SERVICE BULLETIN SPSB008

SUBJECT: RELEASE CABLE TRIMMING

STATUS: MANDATORY INSPECTION

SUN PATH PRODUCTS, INC MAIN CANOPY RELEASE HANDLES (PART NUMBER JP068-1) DELIVERED WITH SYSTEMS WITH DATE OF MANUFACTURE JANUARY 2009 THROUGH PRESENT (FEB 2013). IF THE DATE OF MANUFACTURE OF THE HARNESS/CONTAINER SYSTEM IS BETWEEN 1/2009 AND 2/2013, THE CABLE LENGTHS MUST BE INSPECTED.

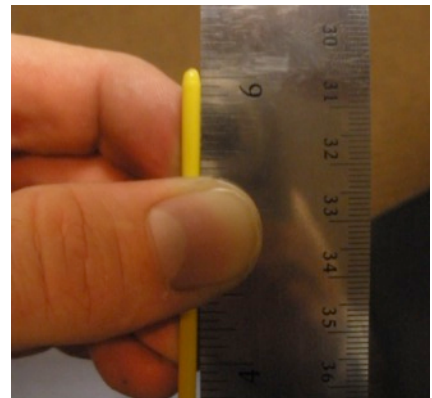
3. Remove any slack in the cables by pulling upward on both sides slightly. (A short tug/or pull on the cable end should take out any slack that may be in the system)
4. Place the rig on the ground or chair and allow the yoke area to relax and ensure your housings are seated/routed as if being worn. Specifically the loop area on the left side behind the main ring cover.
